RE: Full planning permission is being sought for the following development:

Client: Jamie Goldrick

Please find enclosed the further information as requested on the 22nd of June 2022. Enclosed is our response which includes amended drawings and layout plans. When reviewing this application, we kindly ask you to note the following responses.

Image 1: Existing stone pier walls and place name to remain unchanged.

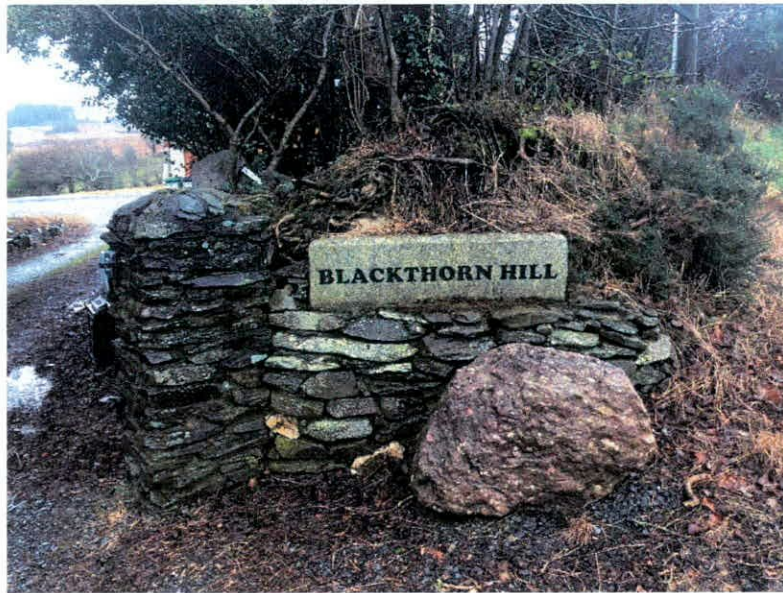
3. The applicant is requested to submit a revised layout with appropriate scale, showing the proposed parking arrangement for the proposed dwelling, and a drawing showing boundary walls at both of existing vehicle access points limited to a maximum height of 0.9m, and any boundary pillars limited to a maximum height of 1.2m, unless maintaining existing entrance arrangements. In preparing these drawings, the applicant should have cognisance of Section 11.3.4(ii) of the Development Plan which states 'driveway and parking areas should be minimised and should follow the natural slope and contours of the site with appropriate permeable materials. Modern gateways, piers and boundary walls should be avoided with the exception of the retention and reinstatement of traditional stone boundary walls.'

There are no proposals in this application to amend the existing entrance, gateway or entrance walls which ensures that there are no modern gateways, piers and boundary walls proposed. The existing site boundaries are to remain unchanged with no proposals to amend the same, see image below.
